From: Tang Lok San <[REDACTED]>
Sent: Thursday, January 15, 2026 10:42 PM
To: tpbpd/PLAND <tpbpd@pland.gov.hk>
Cc: [REDACTED]
Subject: A/YL-KTN/1206 - Supplementary Document

有關規劃署對 A/YL-KTN/1206 的查詢

擬議臨時貨倉 (危險品倉庫除外)
連附屬設施及相關填土工程 (為期3年)

A/YL-KTN/992 的渠務報告詳細

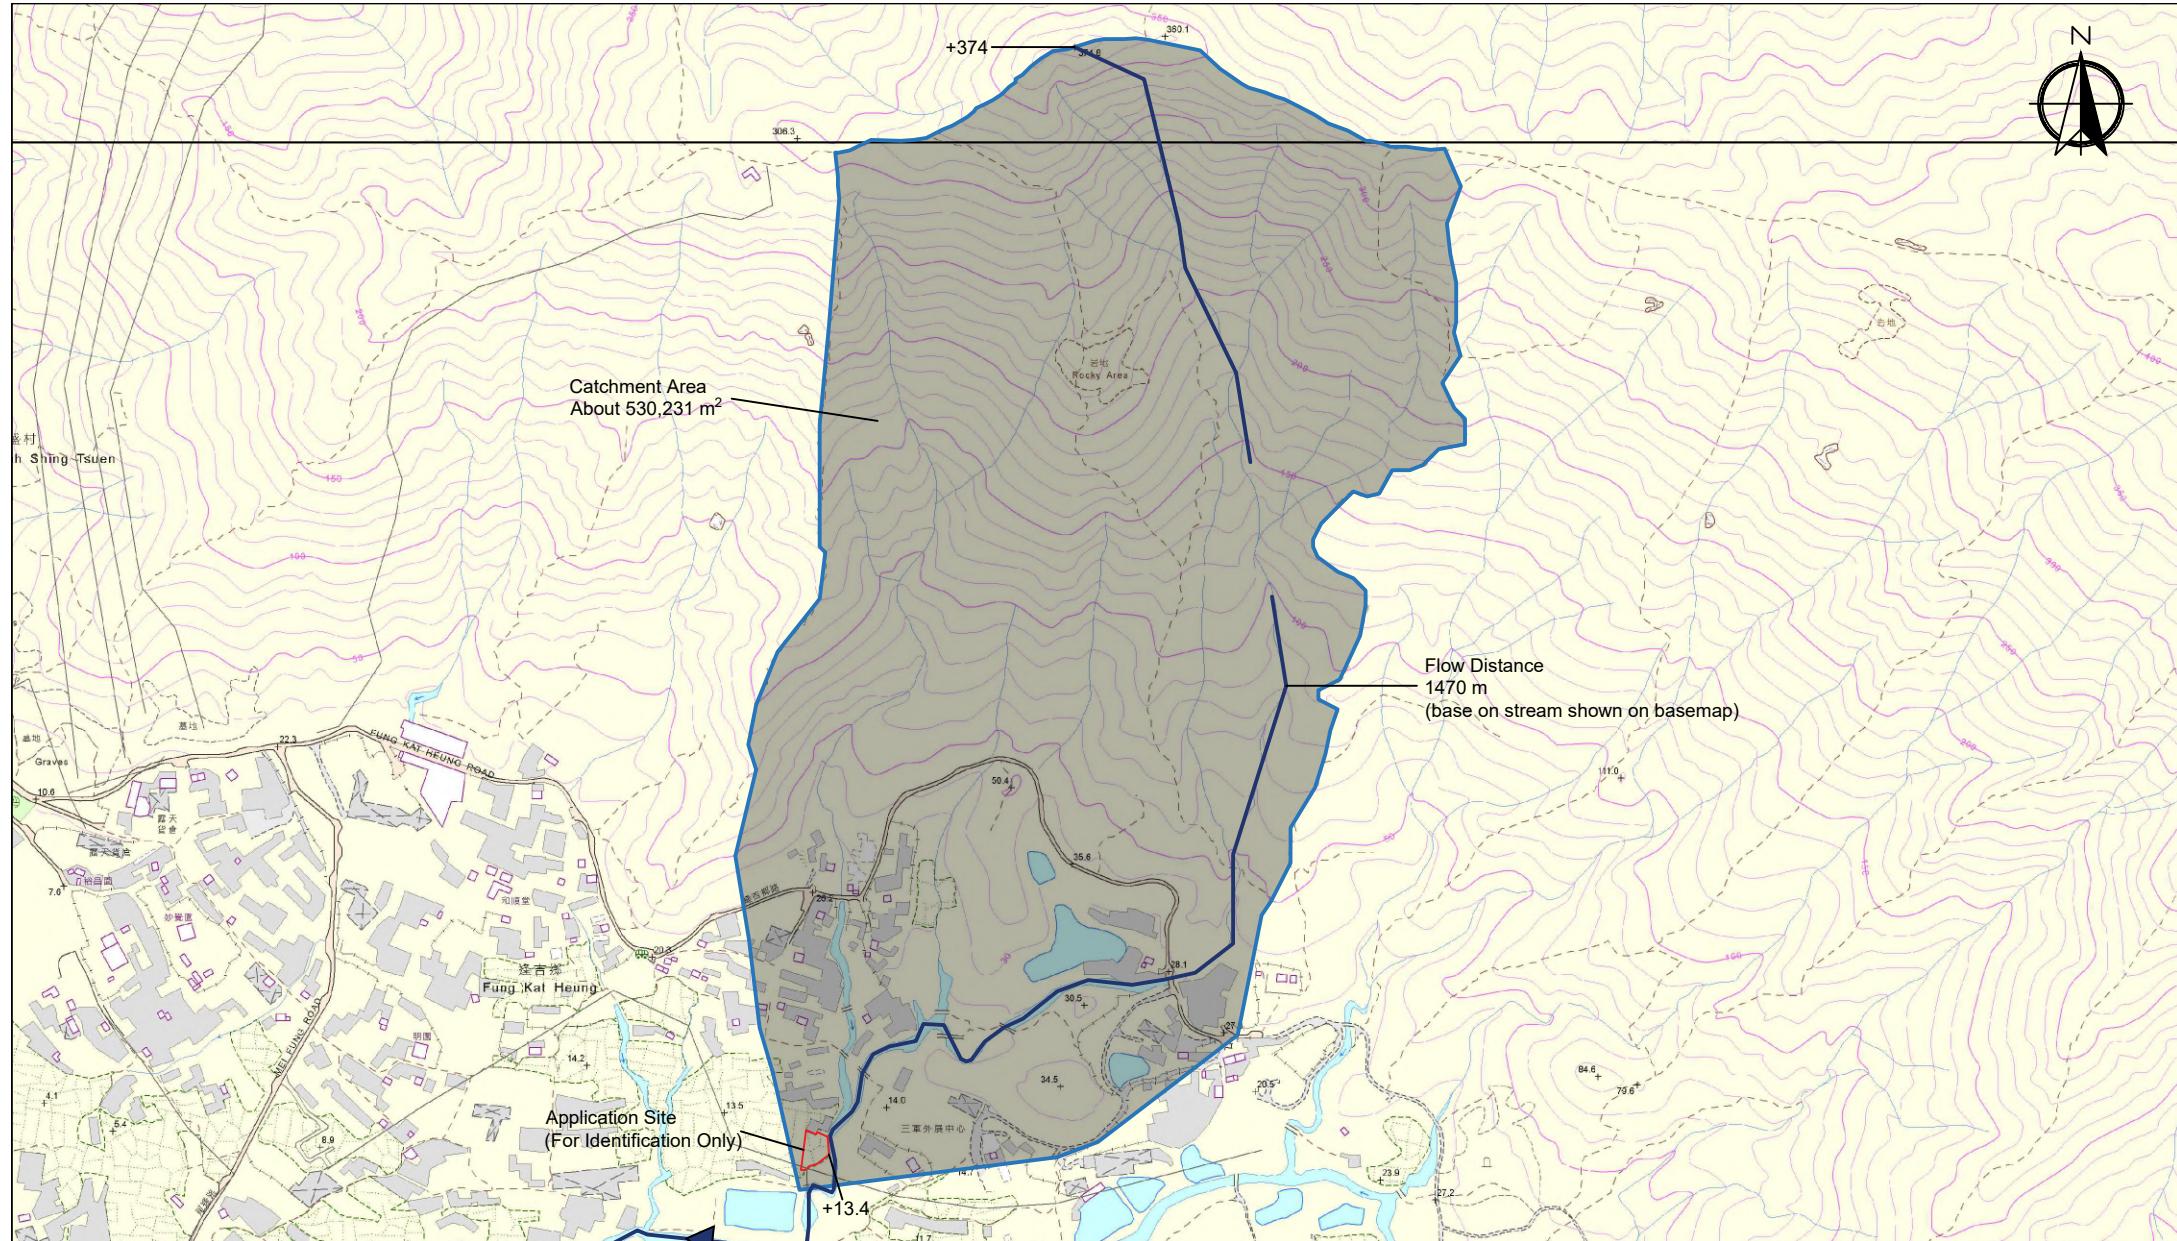
(3)	<i>Please justify the proposed catchment areas. The catchment areas should be determined according to existing topographic levels.</i>	請參考 Appendix 5.2 及 Appendix 5.3。

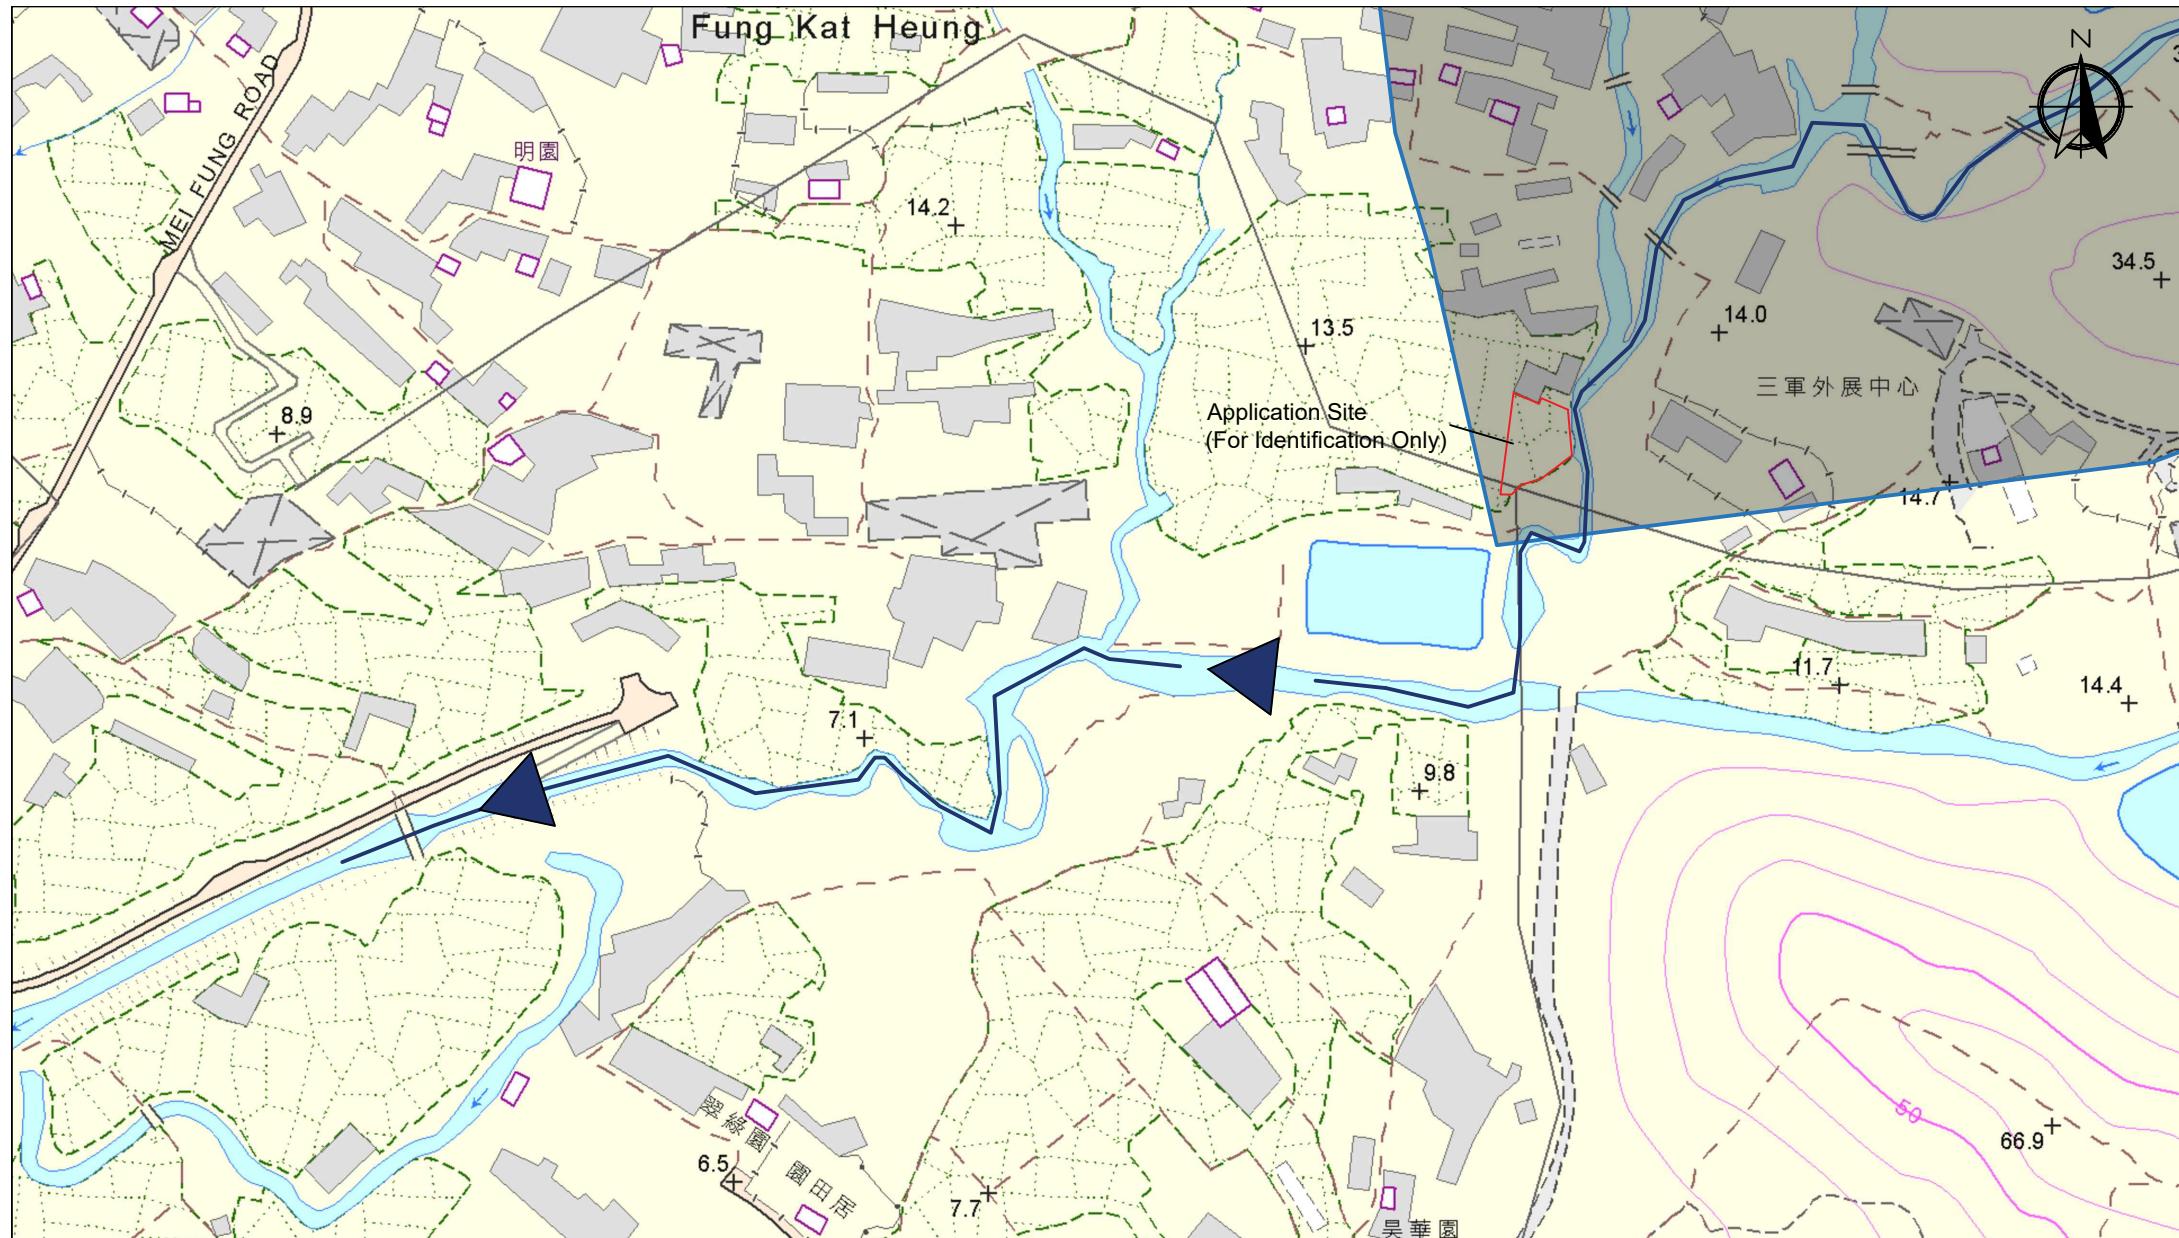
(6)	<i>Please indicate clearly the full alignment of the discharge path from the application site all the way down to the ultimate discharge point (e.g. a well-established stream course/public drainage system).</i>	請參考 Appendix 5 及 5.4。

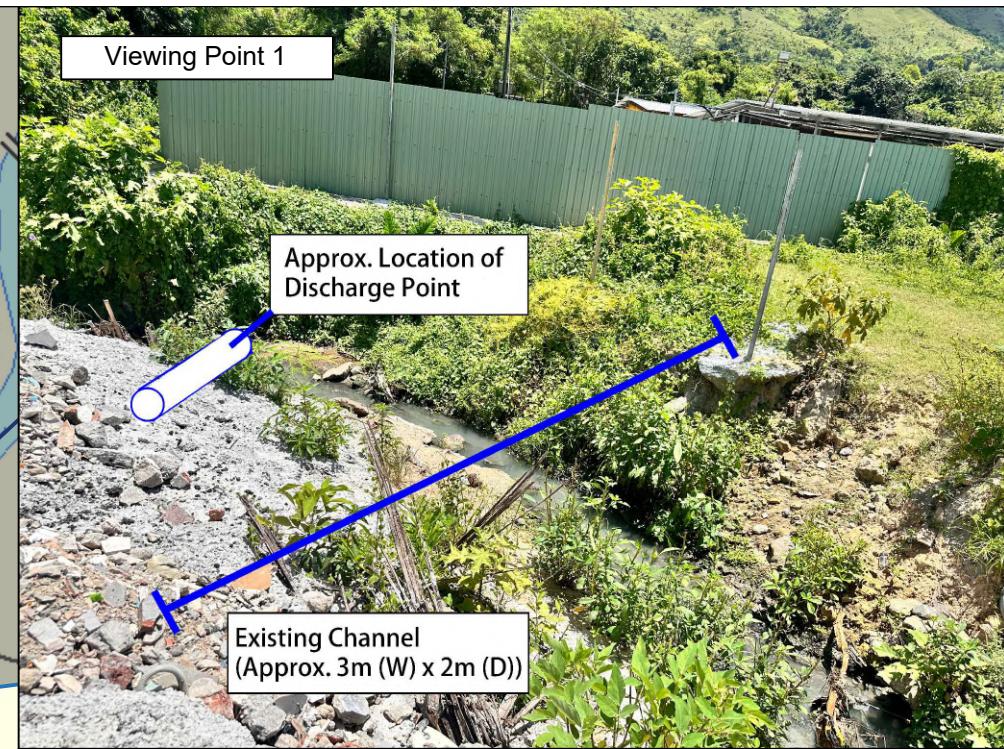
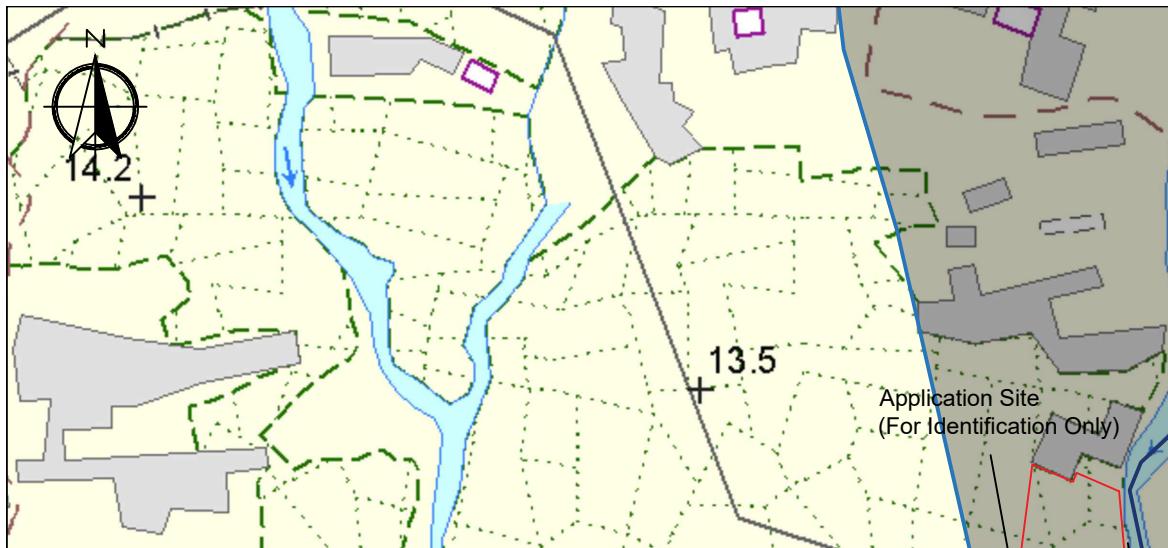
(11)	<i>The applicant should check and ensure the hydraulic capacity of the existing drainage facilities would not be adversely affected by the captioned development. Please provide site photos to show existing condition of the existing drainage facilities which receives the discharge from the application site.</i>	請參考 Appendix – Calculation 及 5.5 。
